RECOMMENDATION MEETING
ADMINISTRATIVE DESIGN REVIEW

SDCI # 3025989 - LU
8105 Greenwood Ave N
& 8111 Greenwood Ave N

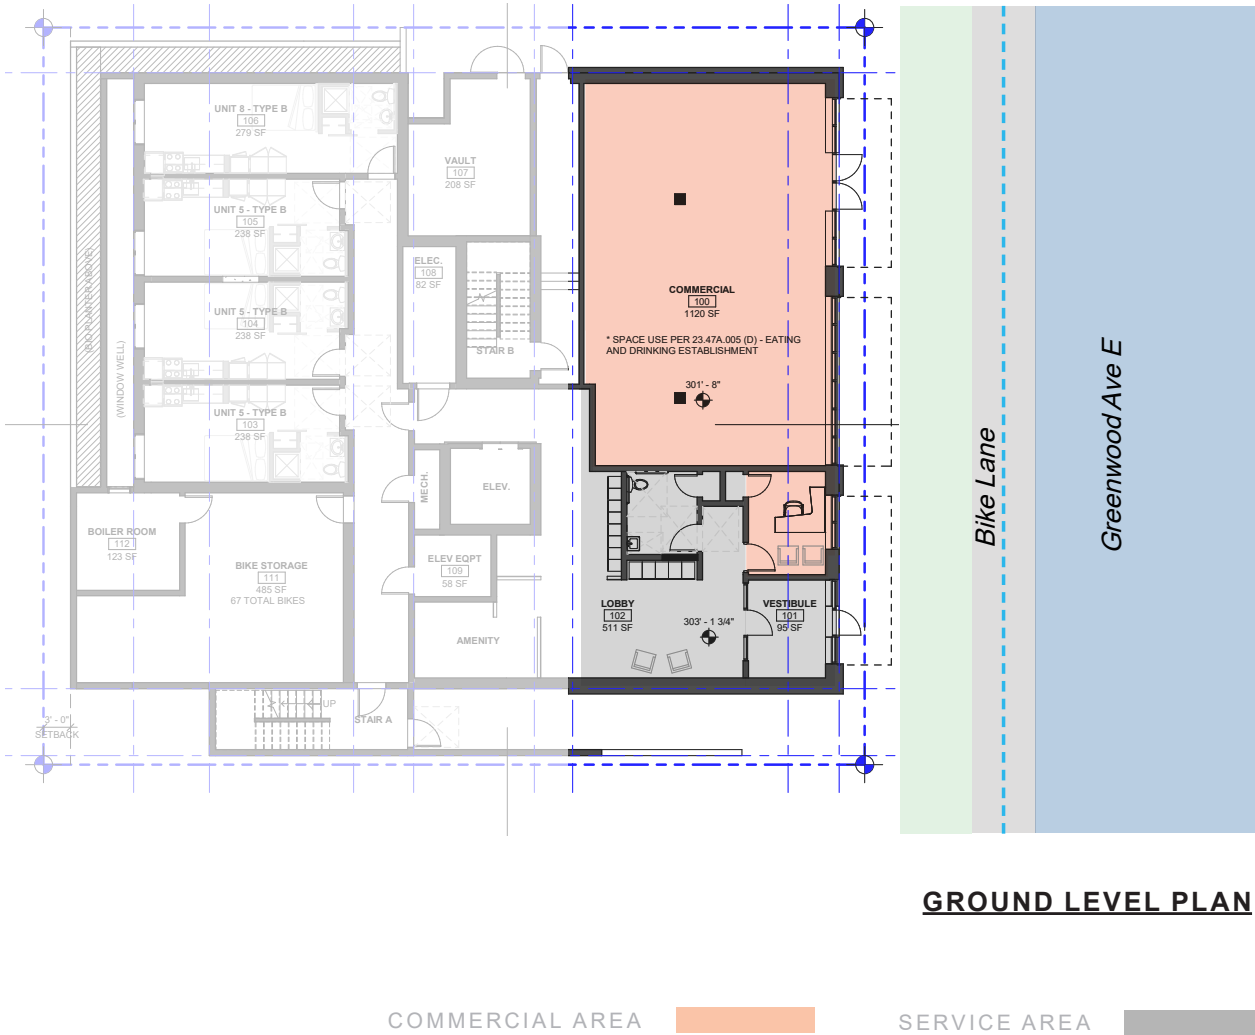
- b. Review the existing context along Greenwood Avenue N to inform the ground level architectural details: podium materials, overhead weather protection, window proportion, entryway patterns, scale and proportion, signage, lighting. Utilize a combination of features to make the residential entry more visible and distinguished from the adjacent commercial uses.

A collection of architectural components organizes the street facing facade: 2-story commercial bays with expressed lintels; brick pilasters that sit proud of the field brick with integrated lighting; kick plates at the bottom of the storefront glazing; and three, deep awnings which reinforce the rhythm of the commercial bays. To differentiate the residential entry, we have recessed it slightly from the adjacent commercial storefront; provided a different window proportion (less tall); added landscape plantings including a long planter which leads to the bike entrance, and also located the building signage over this entrance.

4a

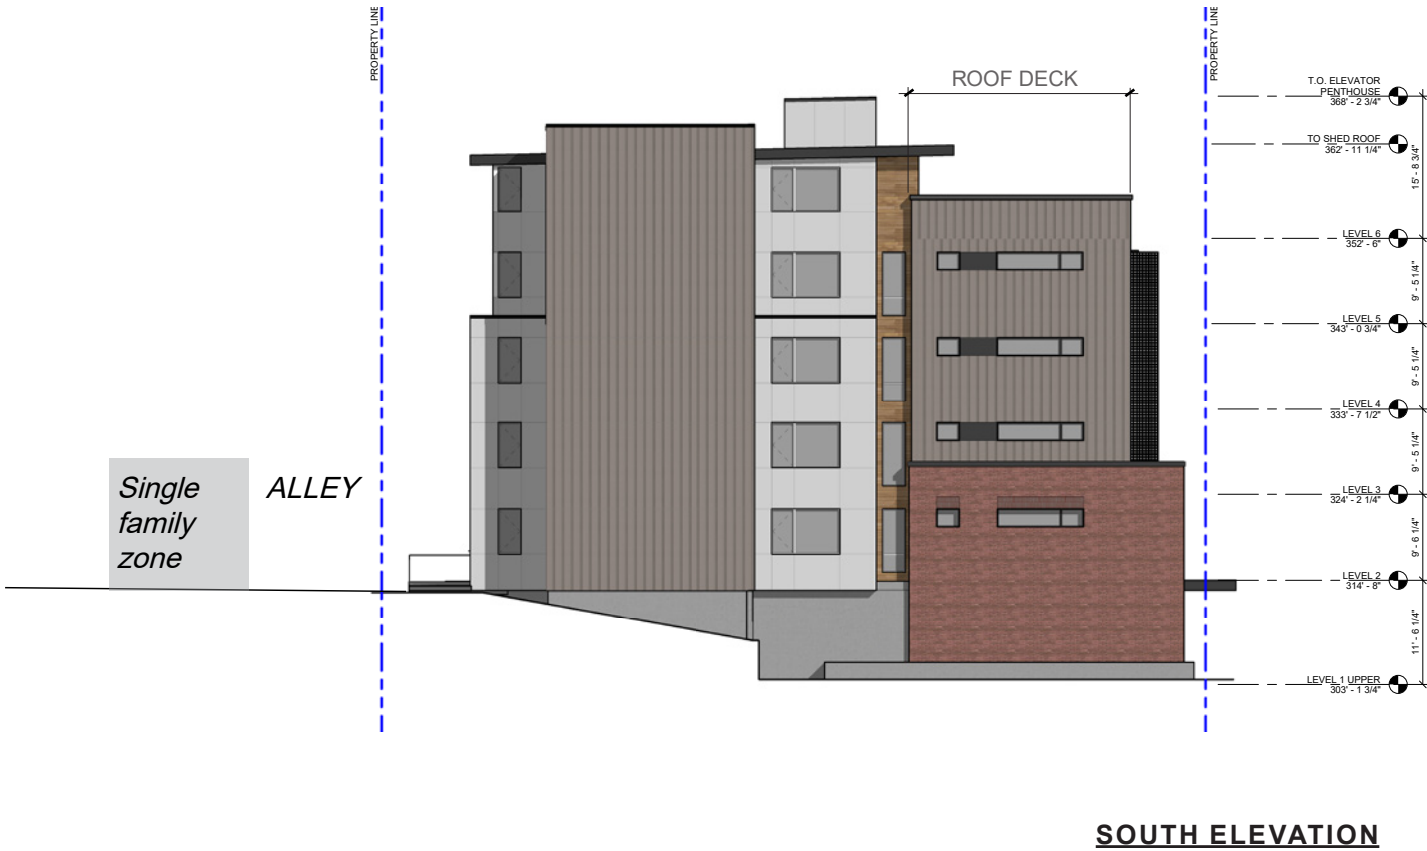
- a. Maintain upper level deck at the east portion of the roof to minimize impacts to the single-family zone.

APPLICANT RESPONSE:
The street-facing upper level deck has been maintained and will also reinforce the relationship of the building to the new park across the street.

4b

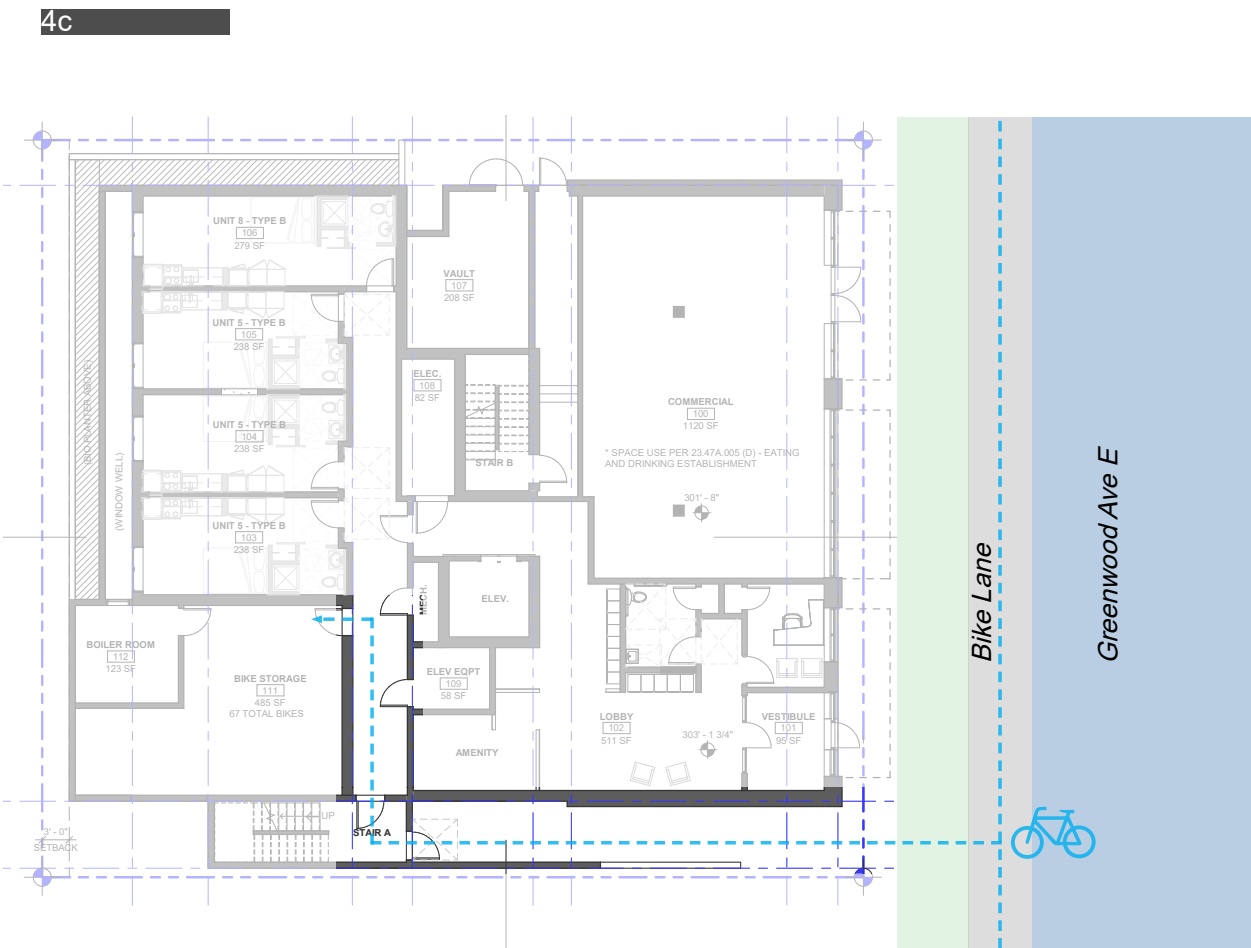
b. Incorporate a semi-private transition between the alley and the residential uses at ground level. Develop a design that utilizes landscaping or other elements to provide a buffer, minimizing the visual and auditory impacts from vehicular traffic.

A semi-private transition between the alley and the residential uses at the ground level is provided with a combination of landscape elements: new ground cover and taller plantings, and a broad bio-planter that nearly runs the length of the alley facade. In addition, the access ramp to the trash room has been with tall plants.

LAND USE CY4 CORRECTION ITEM #2

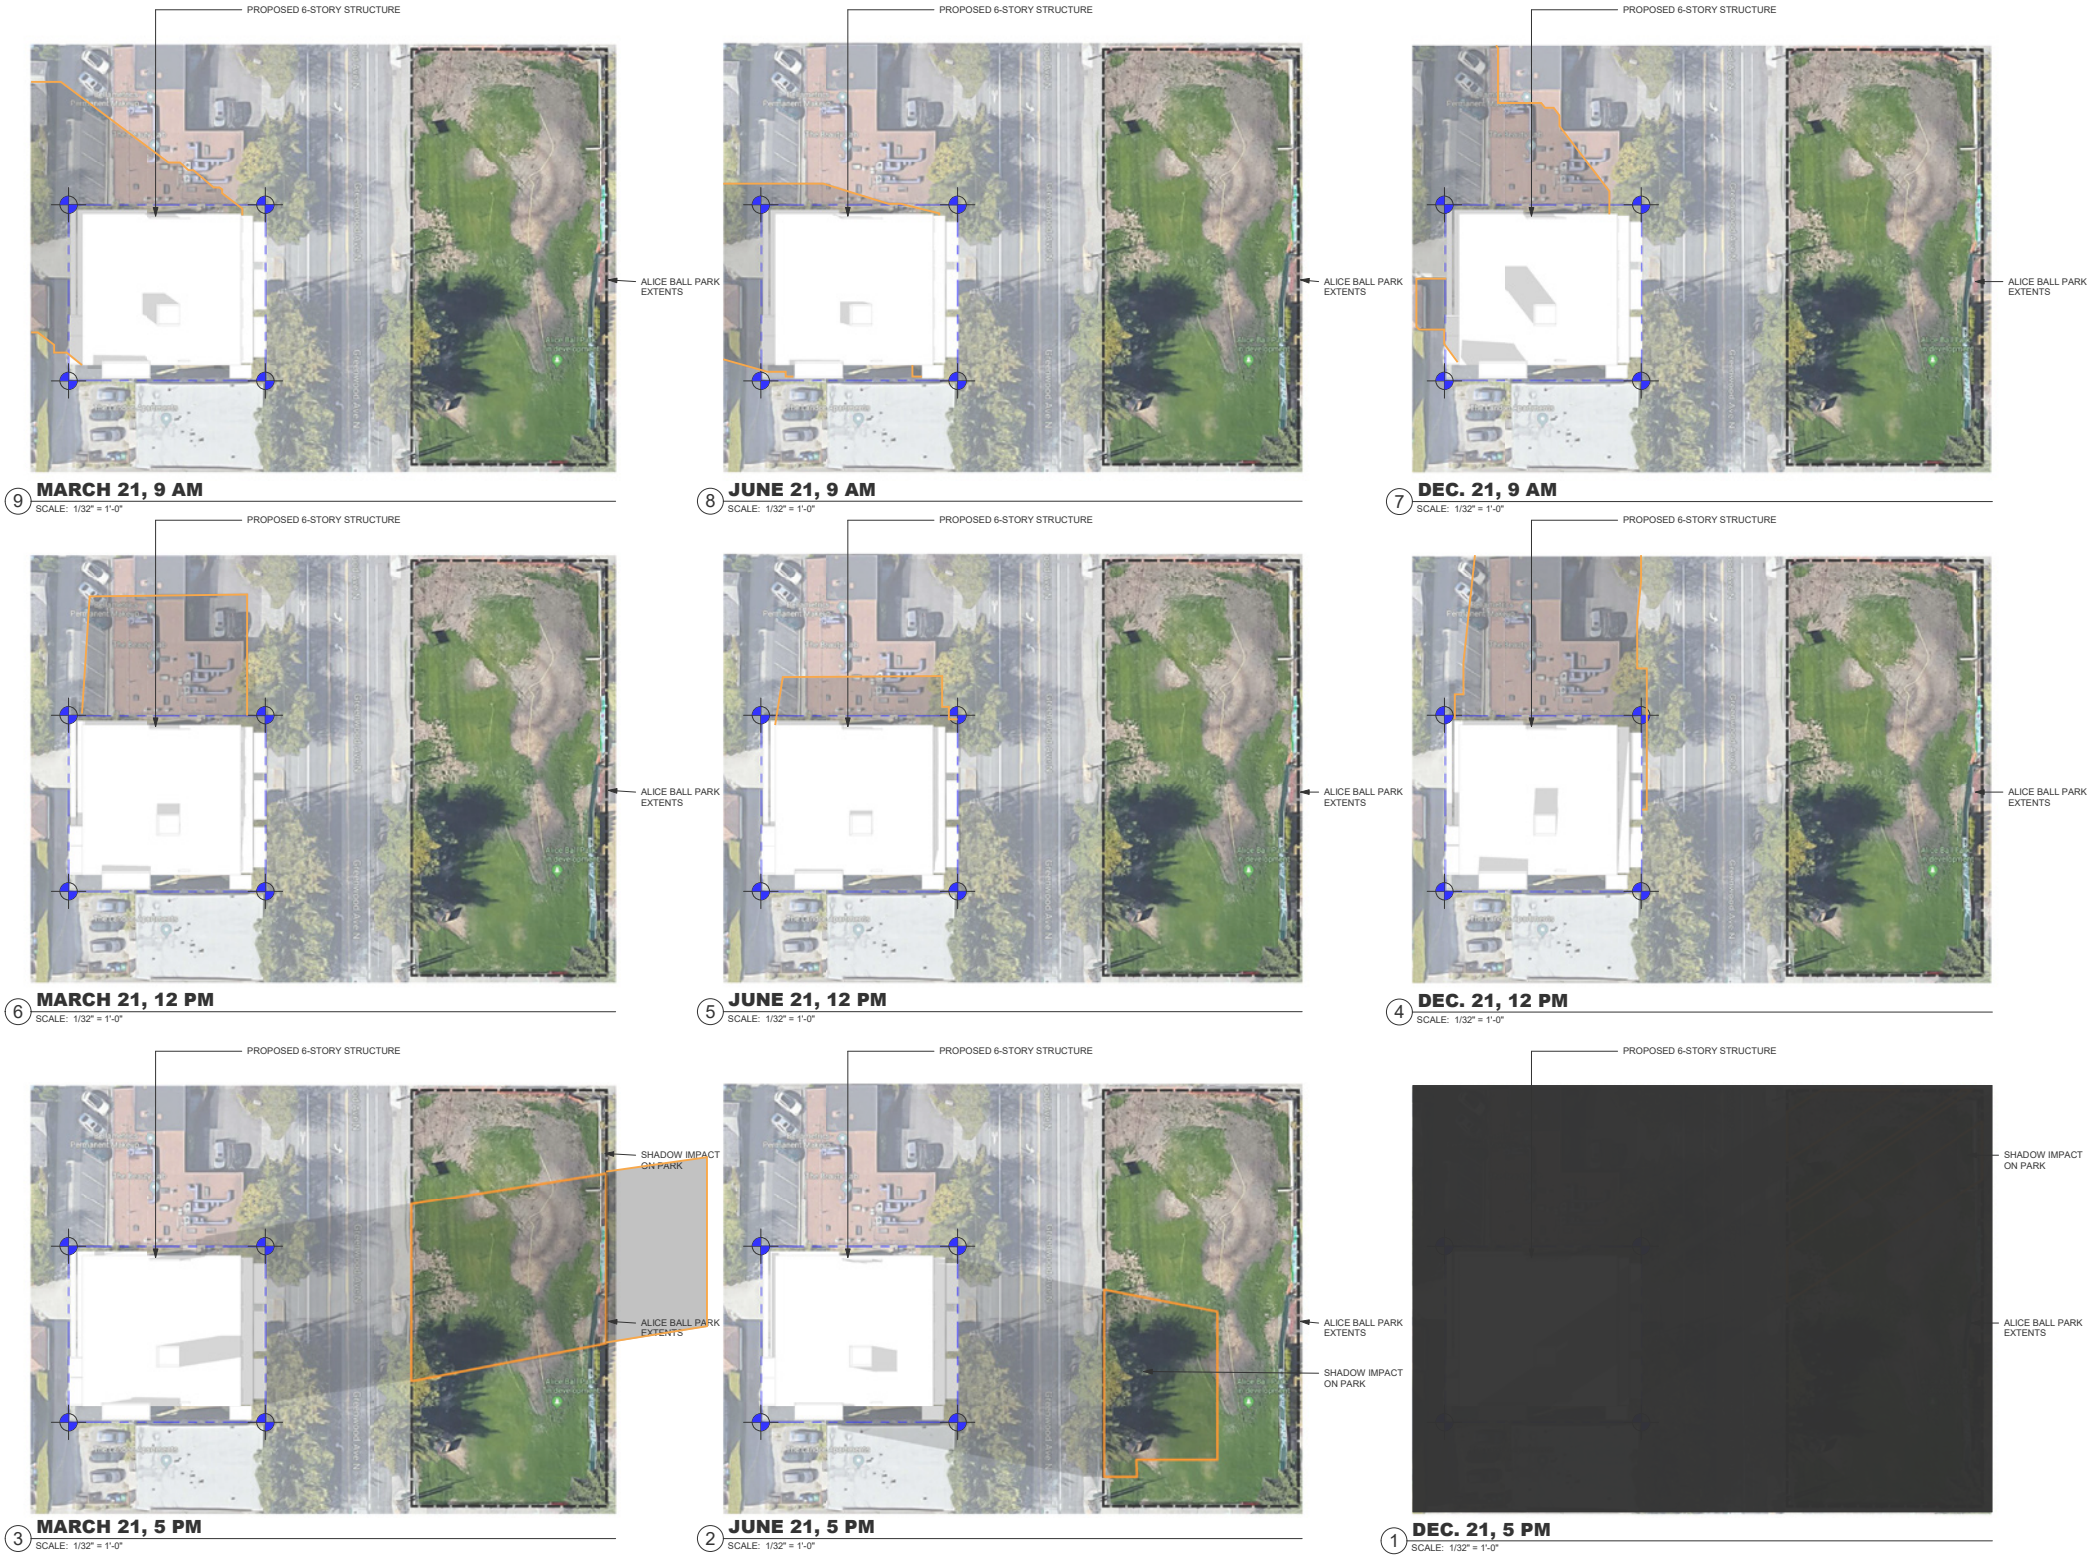
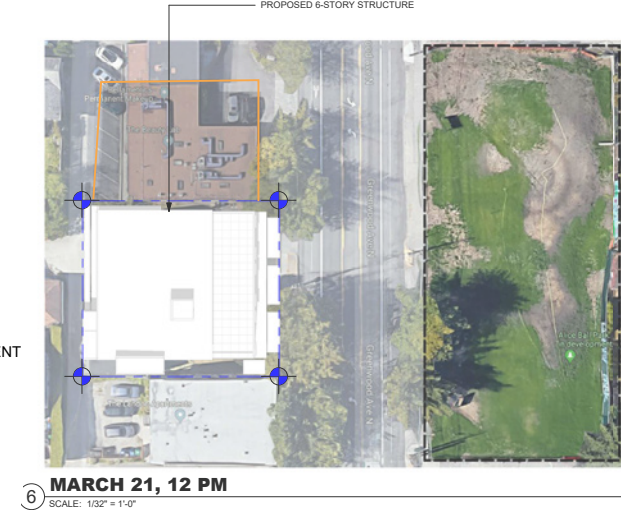
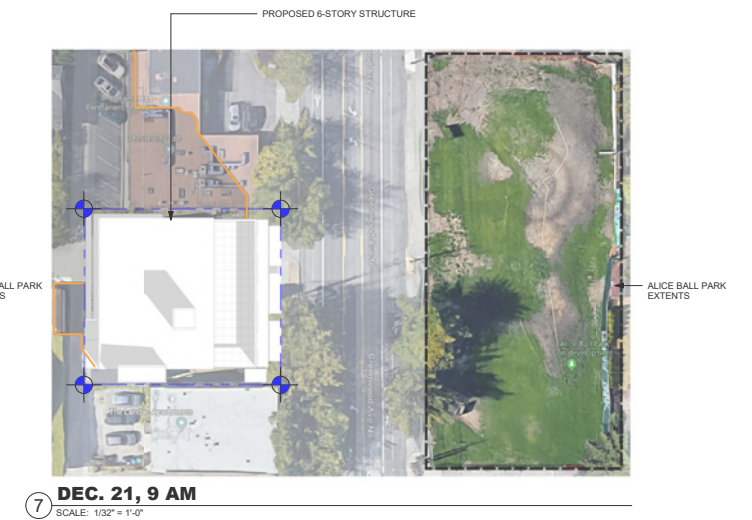
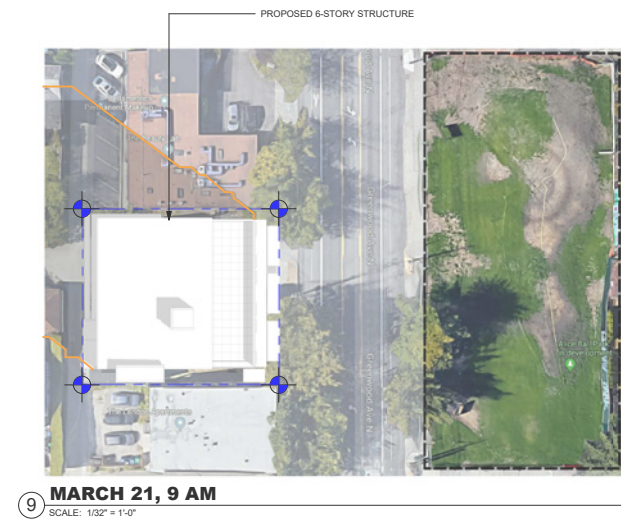
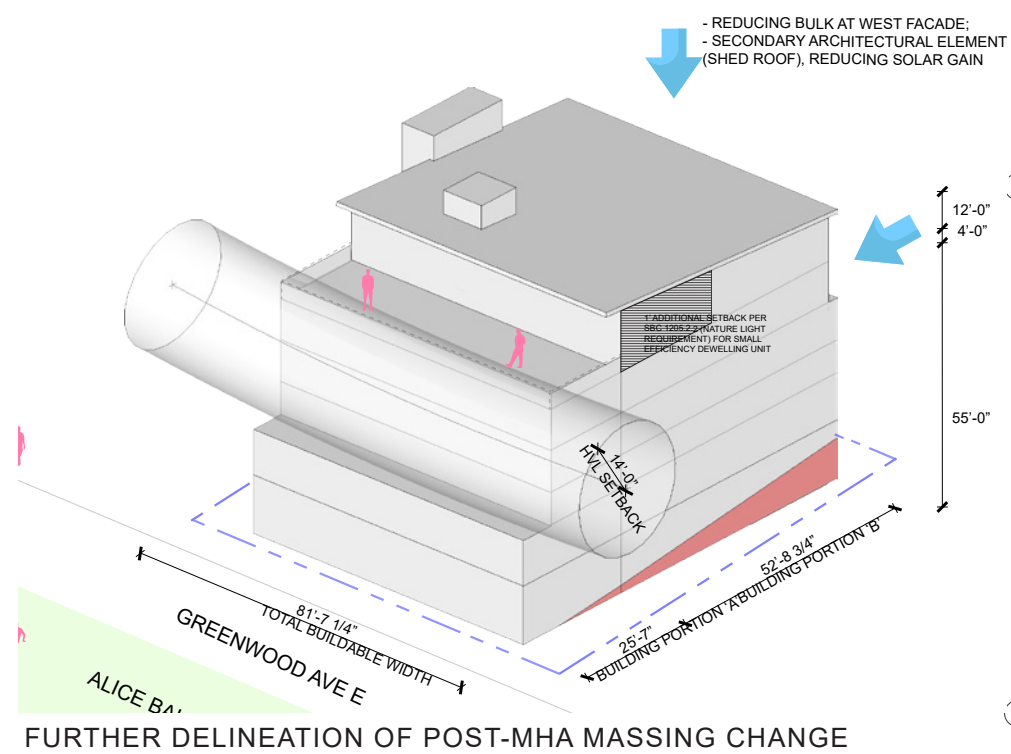
Shadows on Open Spaces, SMC 25.05.675.Q. Demonstrate how you are intending to mitigate the shadow impacts on Alice Ball Park across from the project. Provide shadow diagrams showing alternate massing options that demonstrate less significant shadow impacts on the park.

We have carefully studied other massing possibilities and believe the current design better mitigates the shadows that will be cast on the park in the late afternoon, typically from 5pm to sunset. Please note the following principal design moves that will lessen the depth of shadows cast by the proposed structure:

1. Set back at the street facing facade. Rather than building to the east property line, we have voluntarily set back the whole building approximately 3' from the east property line.
2. Reduce the bulk at street facing facade which will reduce the shadow impacts on Alice Ball Park. We have stepped down the building at the east side facing the park.
3. Provide a shed roof design which is significantly smaller in bulk than a design with a parapet involved. The shed roof lowers the maximum allowable structure height by 4 feet.

Please refer to the comparison shadow study between the maximum development massing and the further delineation massing. We hope this study will address the issue you raised on LAND USE CY4 correction item #2.
